Docket Number:	24-OPT-03
Project Title:	Soda Mountain Solar
TN #:	269352-6
Document Title:	Staff Memorandum on Record of Proceedings_Attachment 5
Description:	Admin Record - Part 5 of 5
Filer:	Ngoc Tran
Organization:	California Energy Commission
Submitter Role:	Commission Staff
Submission Date:	3/27/2026 3:25:46 PM
Docketed Date:	3/27/2026

Begin Bates	End Bates	Unified Title	Primary Date/Time
SMSP02515	SMSP02517	Fw: Soda Mountain visual resources- figure question	12/16/2025 14:25
SMSP02518	SMSP02520	68347_SodaMountainSolar_KOP 10 7-25 (1).pdf	12/16/2025 14:05
SMSP02521	SMSP02522	Re: Soda Mountain- Operations at new LADWP switchyard	12/5/2025 11:32
SMSP02523	SMSP02523	Fw: Soda APMs/MMs	12/9/2025 15:30
SMSP02524	SMSP02641	SodaMtn_APM_MM_Summary 2025 1209.docx	12/9/2025 15:18
SMSP02642	SMSP02645	Fw: Soda Mountain visual resources- figure question	12/17/2025 10:52
SMSP02646	SMSP02646	68347_Viewshed_5mi_20251217.jpg	12/17/2025 10:54
SMSP02647	SMSP02647	68347_KOP_Simulation_Locations_20251217.jpg	12/17/2025 10:54
SMSP02648	SMSP02648	68347_KOP_Simulation_Locations_20251217.pdf	12/17/2025 10:47
SMSP02649	SMSP02649	68347_Viewshed_5mi_20251217.pdf	12/17/2025 10:46
SMSP02650	SMSP02650	Fw: Fi

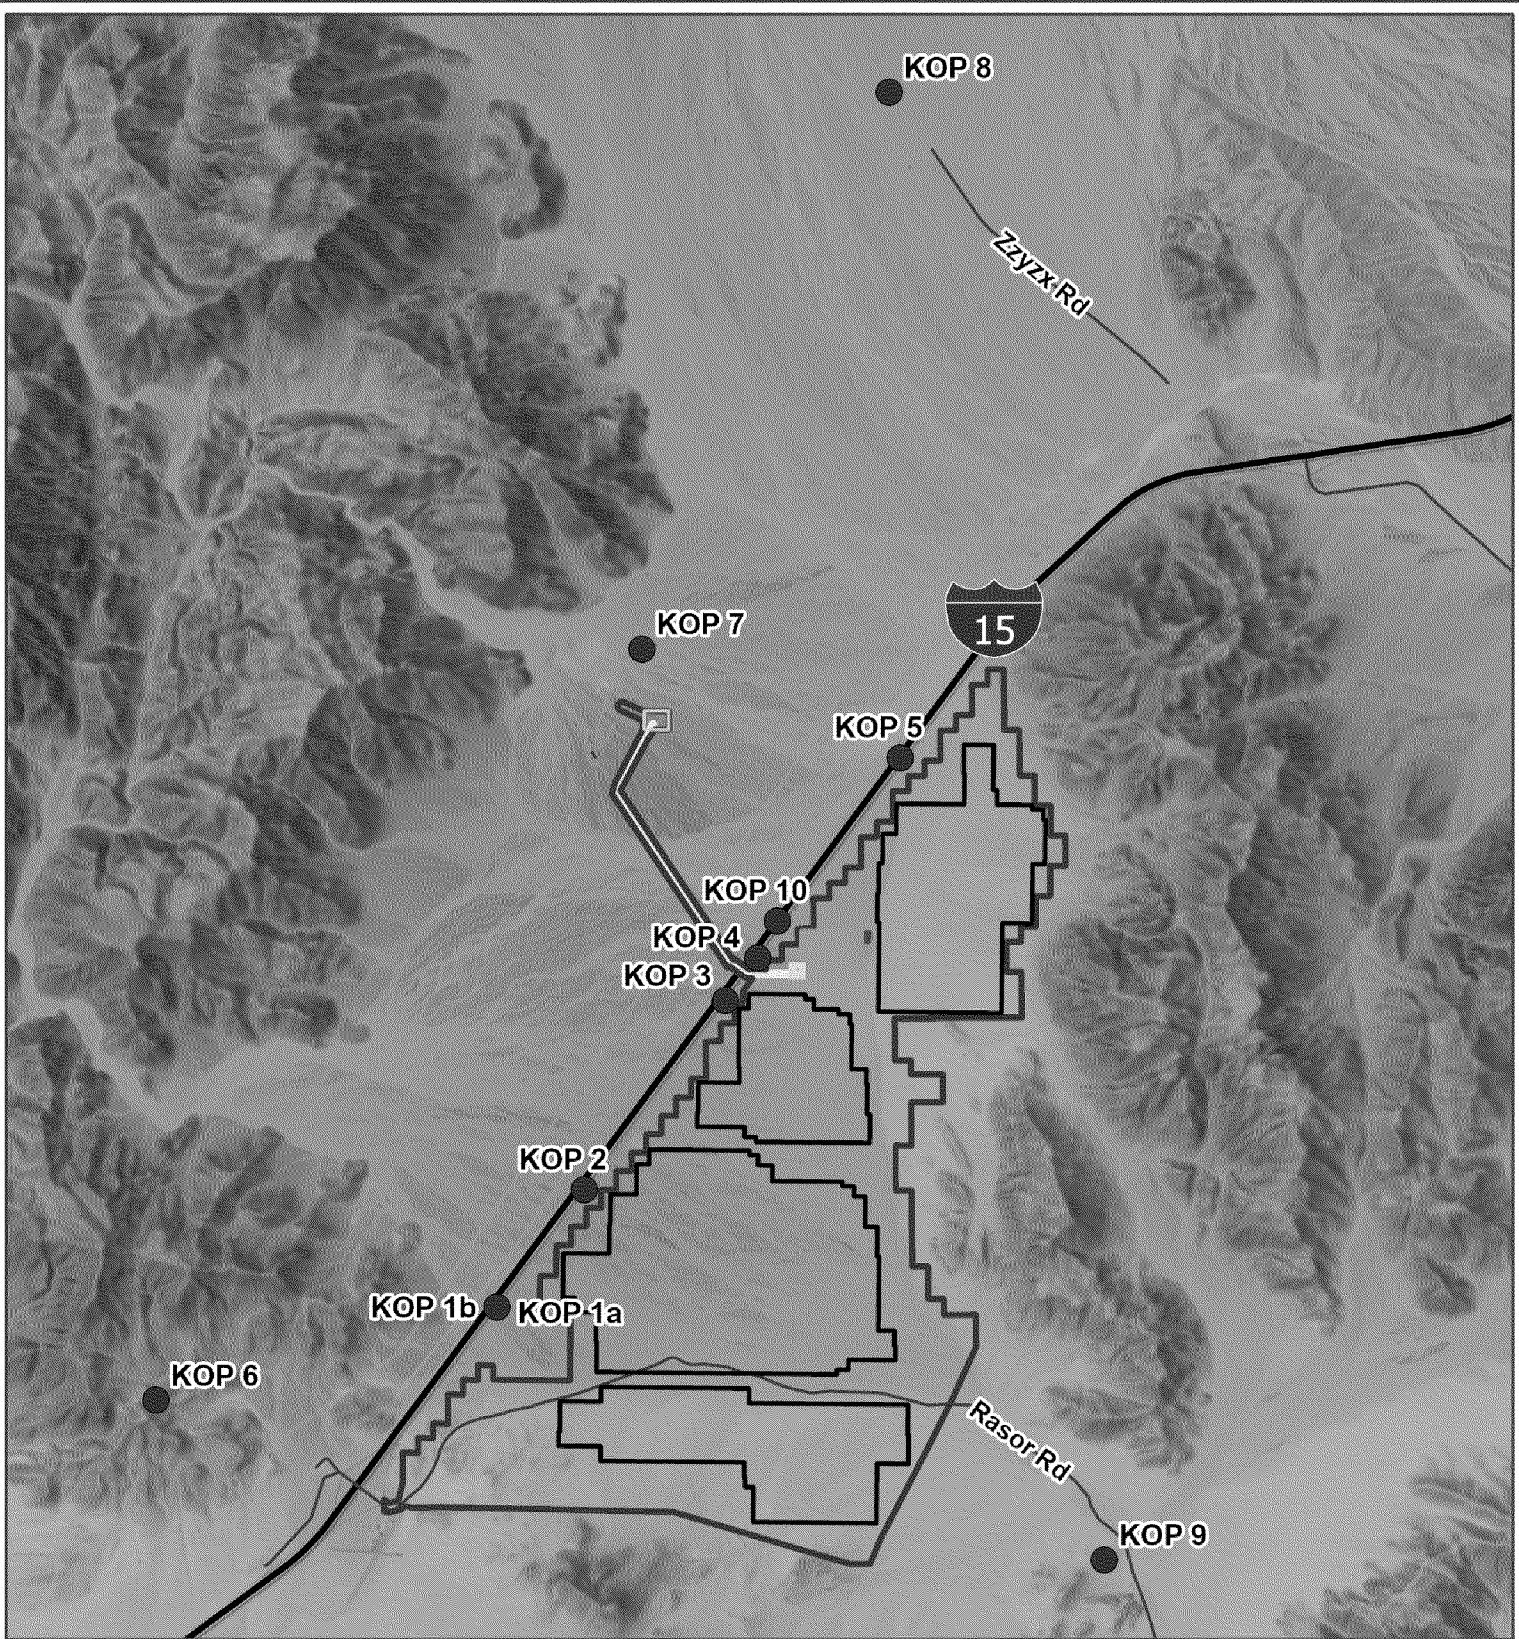
Can you update Figure 3.1-3. Preliminary viewpoints and KOP simulation locations from 3-1 Aesthetics - Revision July 2025 to include KOP 10? Once you update and docket it, I can send Visual Resources to formatting.

Hi! Please see attached for - Added KOP 10 (Q) to both Aesthetics Figures (3.1-3 and 3.1-4).

Figure 5 Alternative Project B Components

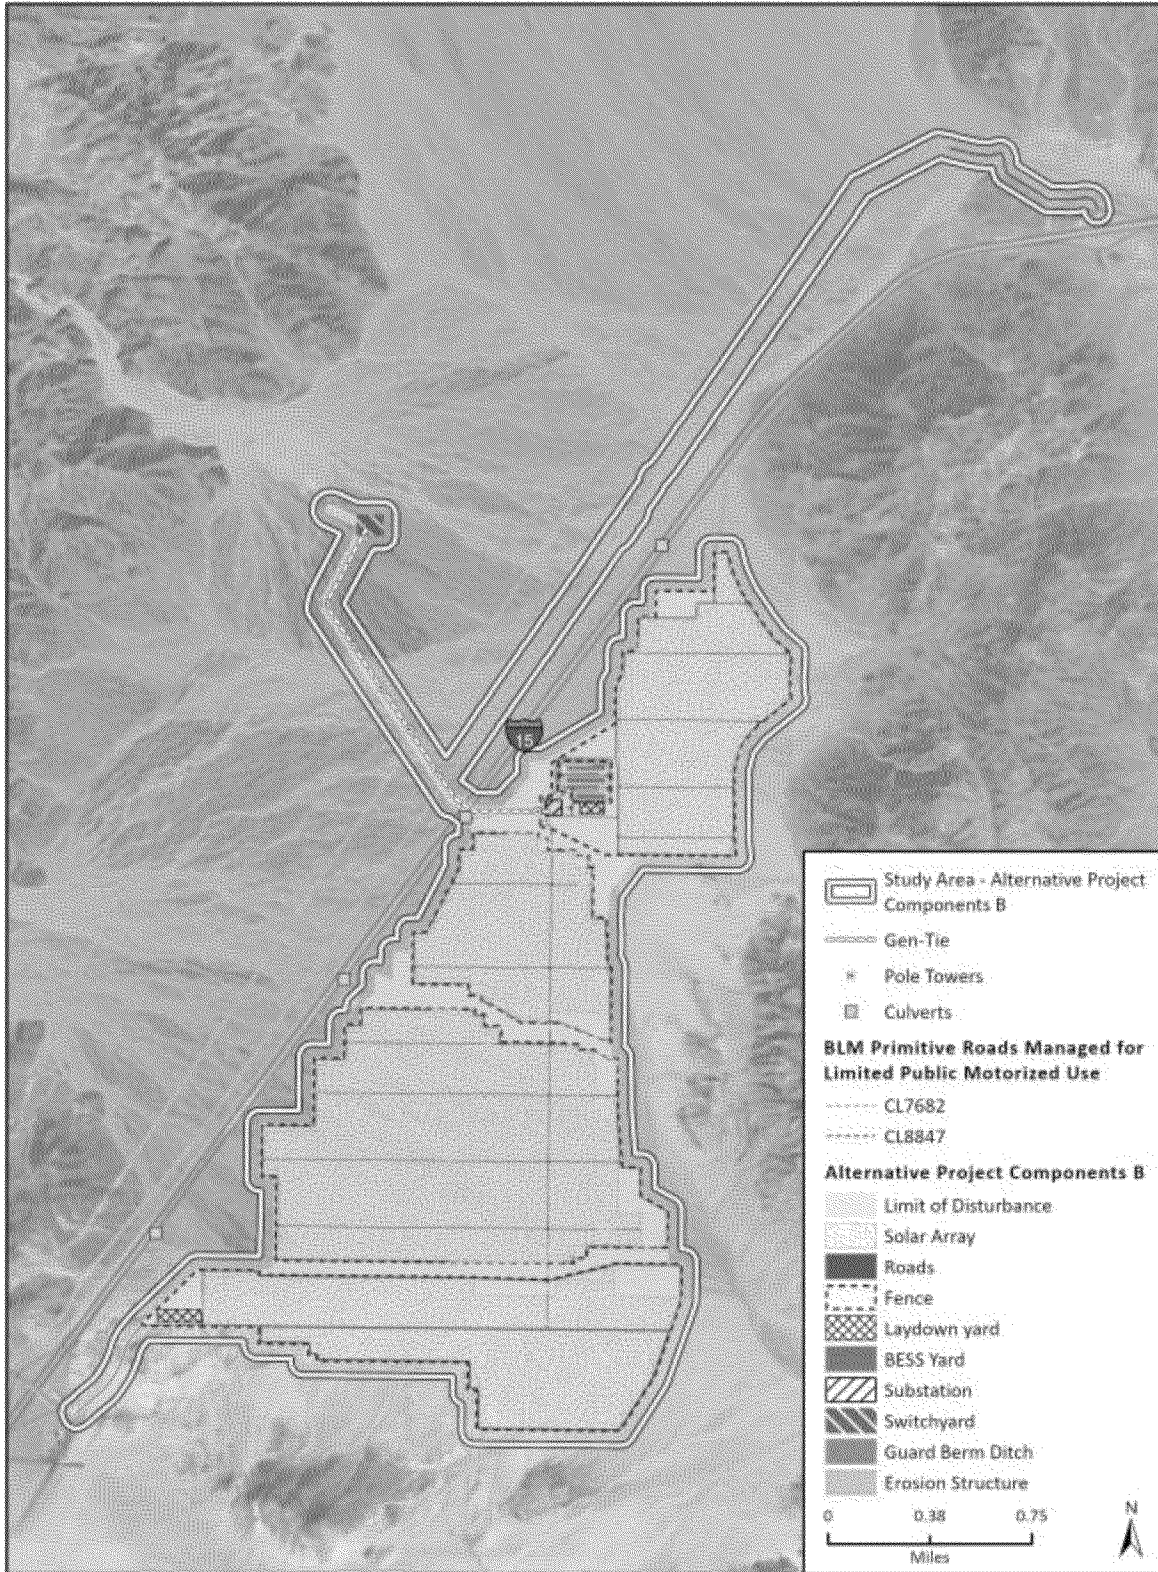
Lisa requested that we update Figure 3-9 (attached) in her email below. Could you please clarify if you want the new project components (alternative project components B)? This figure is referencing the old project plan, so just want to ensure you get the figure you need.

Figure 3-9 Proposed Stormwater Infrastructure

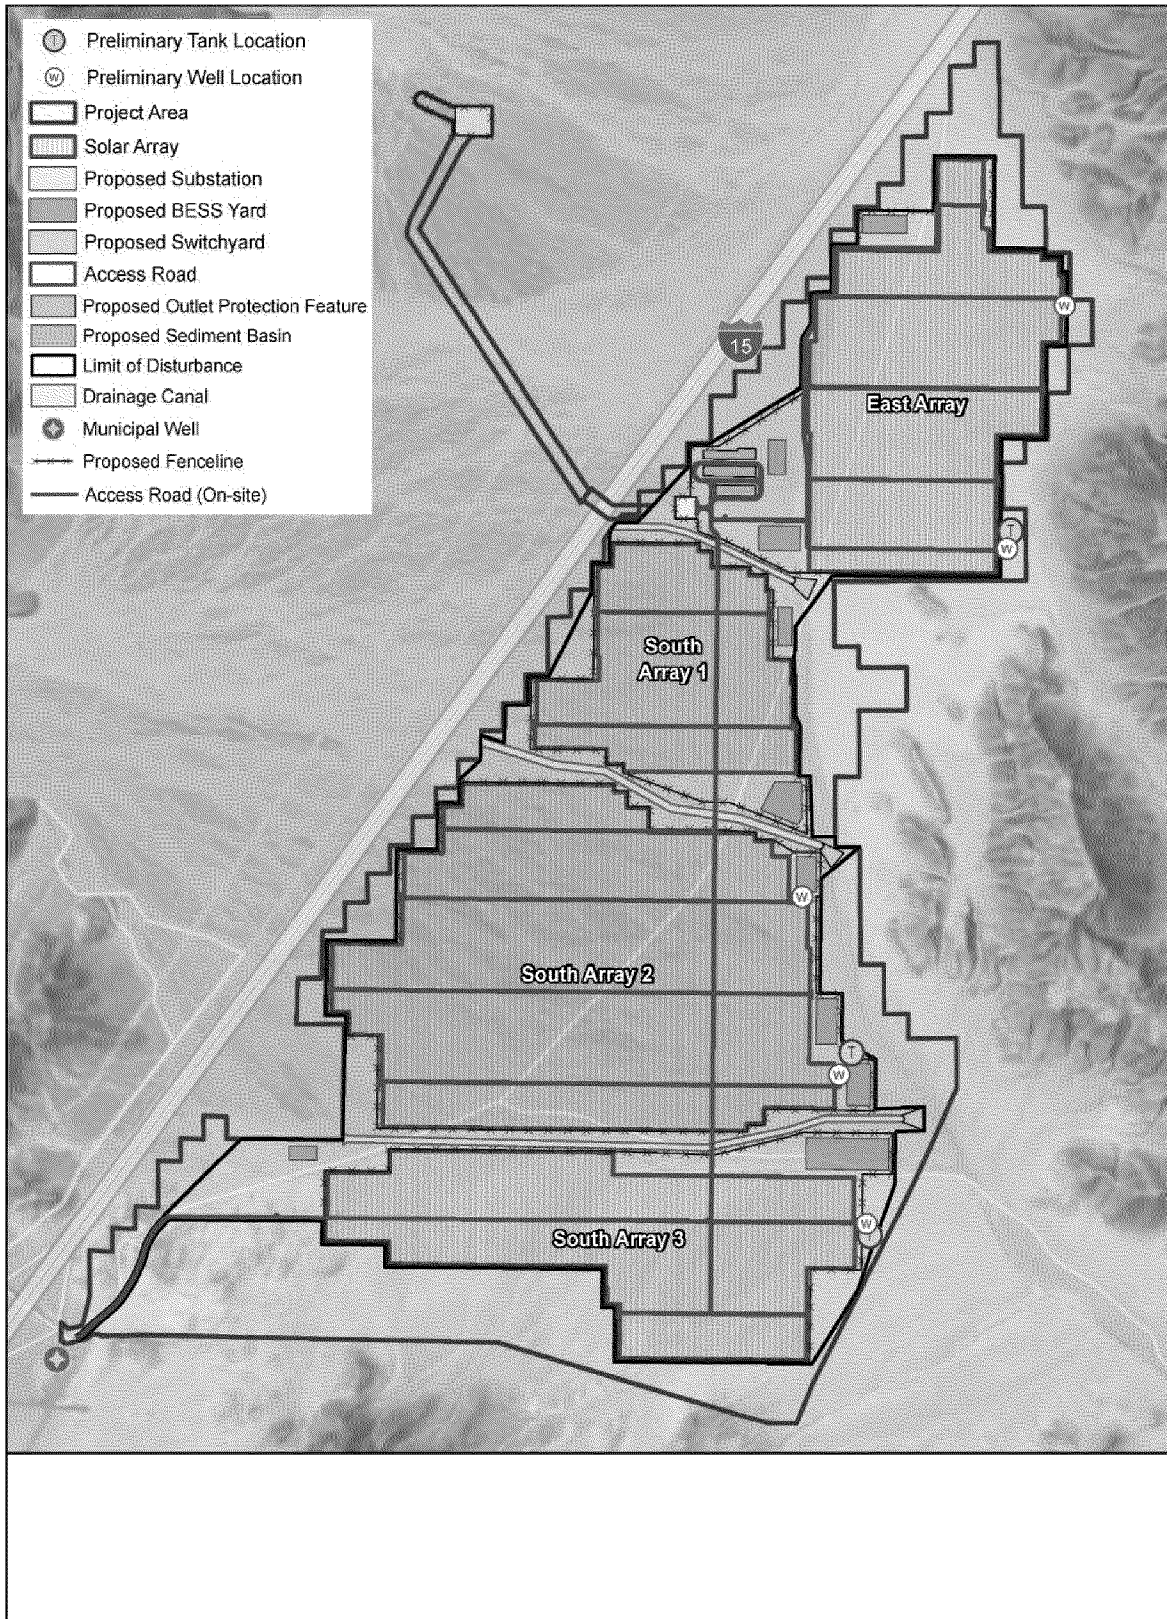
We will also need an updated project figure showing the updated stormwater features. See SA Figure 3-9.

Would it be possible to make the updates to the original Figure 3-9 and remove the proposed outlet protection features (bright green), proposed sediment basins (aqua), and drainage canals (light blue)?

Within the project description, I'm thinking of leaving the current Figure 3-9 as is to show the original proposed stormwater infrastructure. We updated some of the language explaining the changes and I think it'd be helpful to have an updated figure to accompany that. That said, can you provide an updated Figure 3-9 and remove the proposed outlet protection features (bright green), proposed sediment basins (aqua), and drainage canals (light blue)?

25-17245 JD
Fig Y Alternative Project Components B

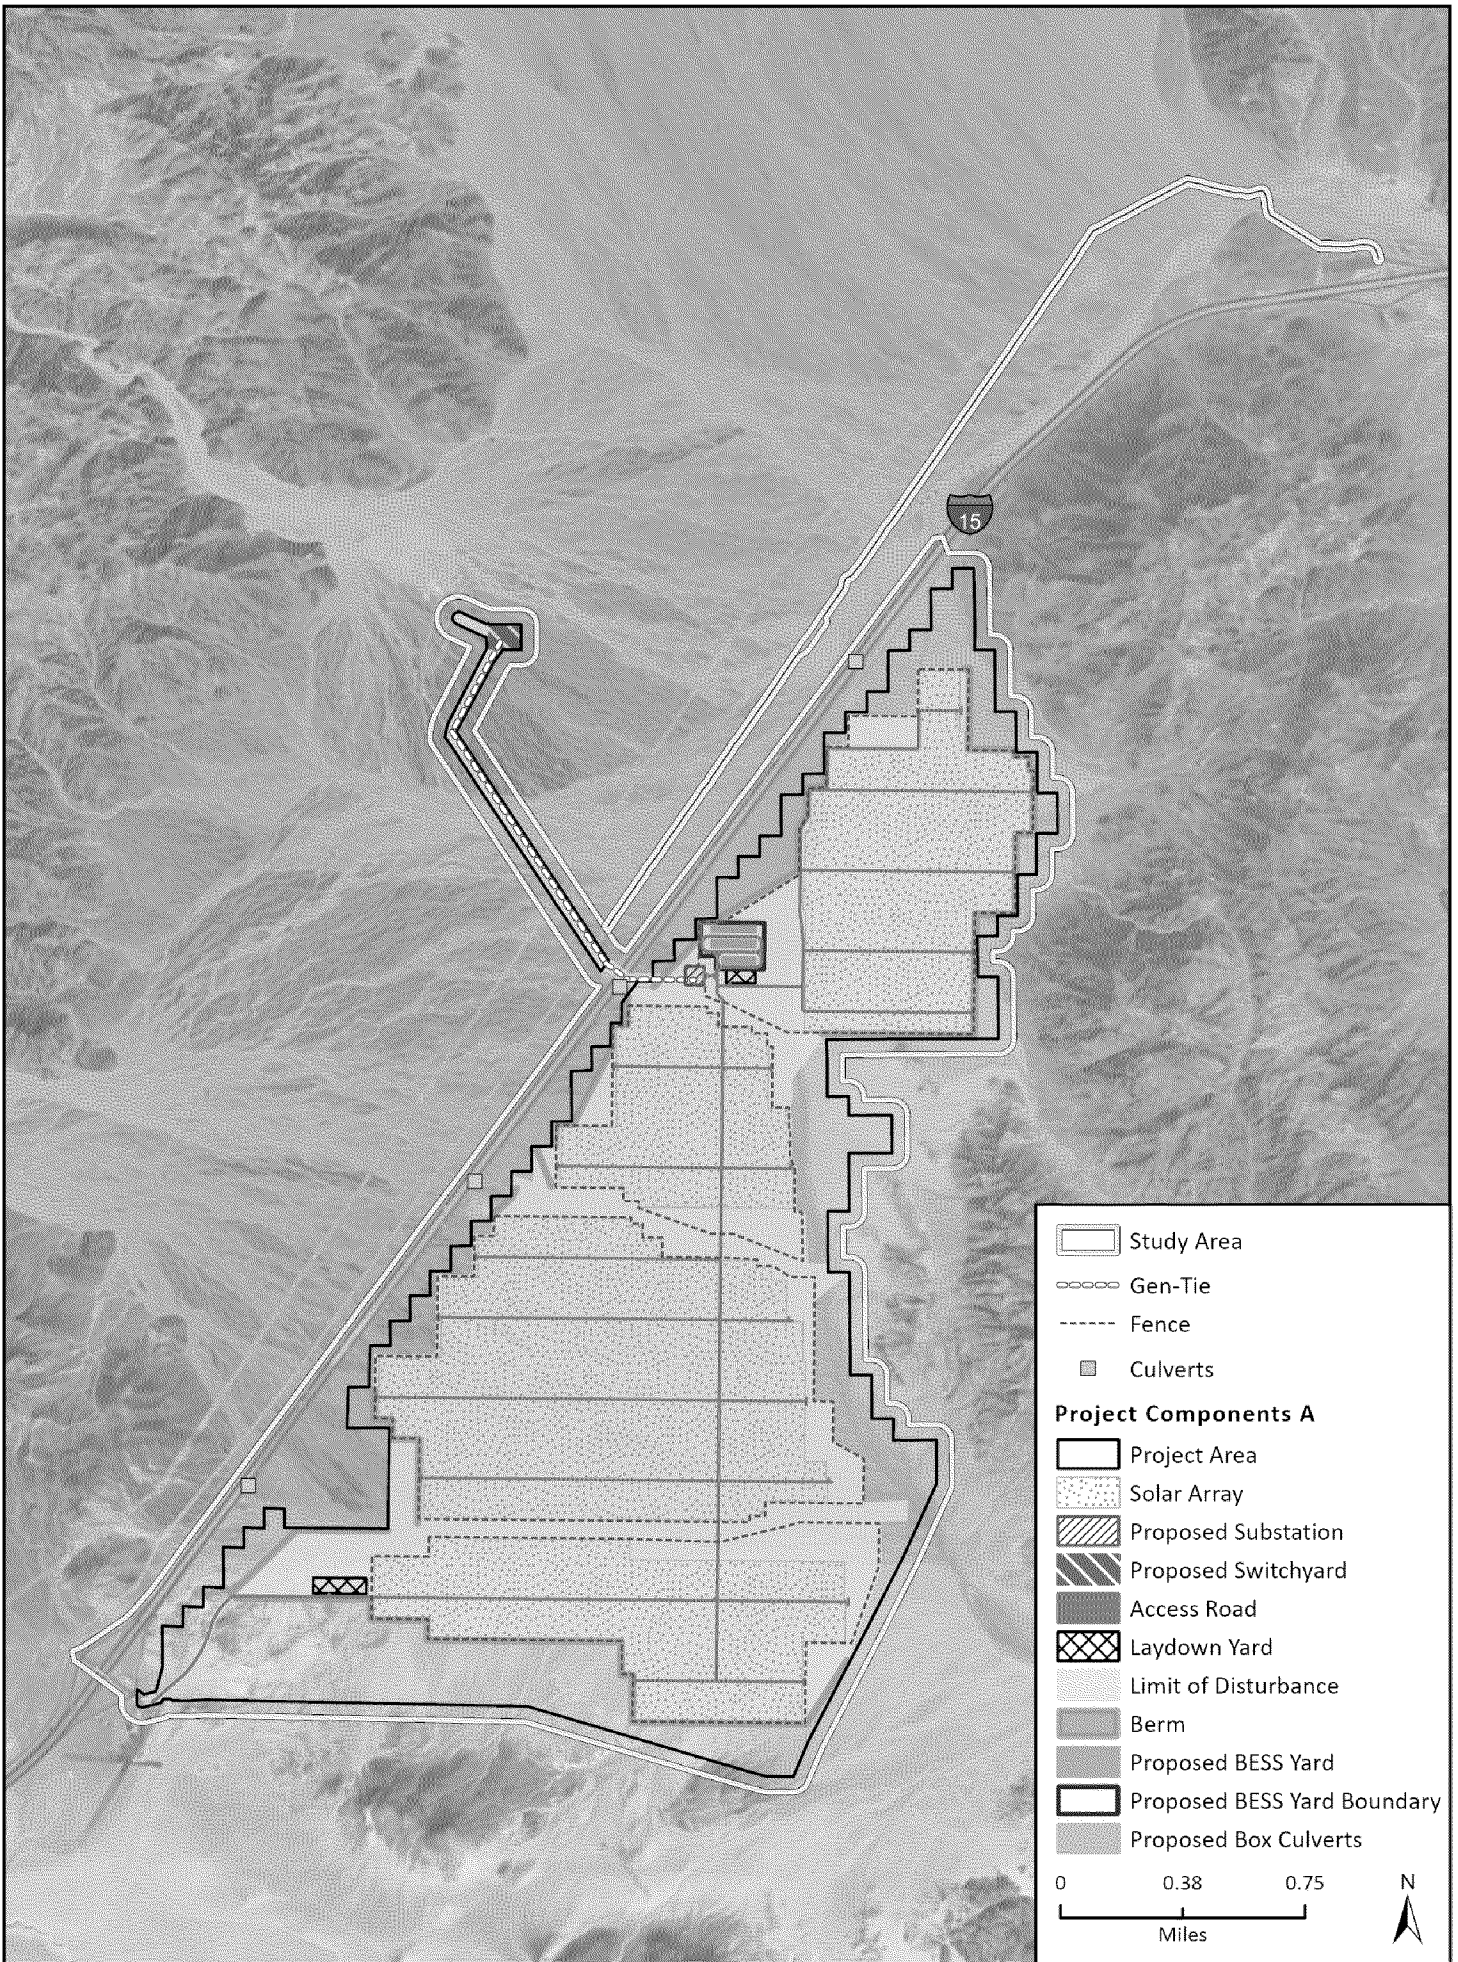
Within the project description, I'm thinking of leaving the current Figure 3-9 as is to show the original proposed stormwater infrastructure. We updated some of the language explaining the changes and I think it'd be helpful to have an updated figure to accompany that. That said, can you provide an updated Figure 3-9 and remove the proposed outlet protection features (bright green), proposed sediment basins (aqua), and drainage canals (light blue)?
